Maine Public Utilities Commission

Maine Distributed Solar Valuation Study: Addendum

March 25, 2015

**Re: Addendum to PUC Report on the Value of Distributed Solar Energy
Generation in Maine**

Figure A-1. Selected Base Case fleet output on ISO-NE load duration curve.

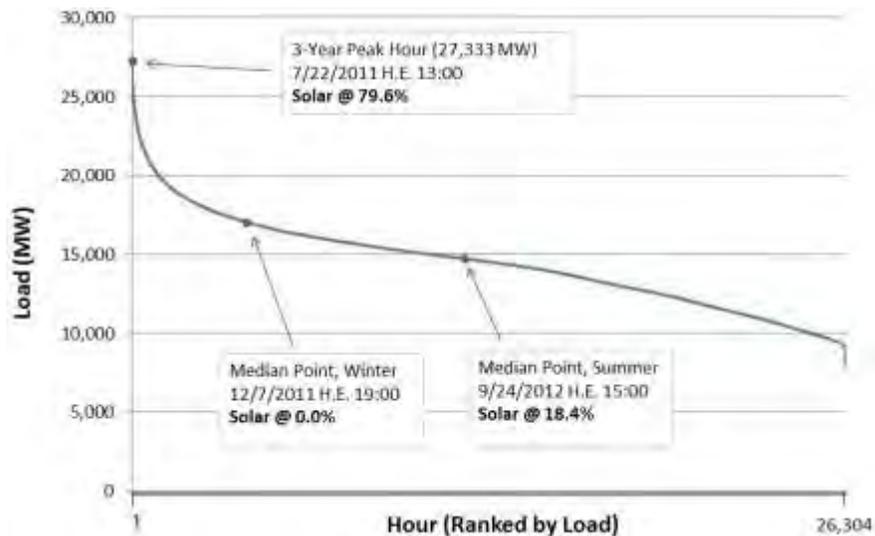
A further investigation indicates that the median output over the summer season intermittent reliability hours occurs on September 24, 2012, in the hour ending 15:00. The fleet output was 18.4% as indicated previously. However, as shown in Figure A-1, the ISO-NE load during that hour was only 14,733 MW, when the control area load was only about half of its maximum of 27,333 MW. Median output during the winter hours occurs at 12/7/2011 at hour ending 19:00, when load was 16,974 MW. These two points define the effective capacity using the SCC method, despite the fact that they do not represent peak load hours.
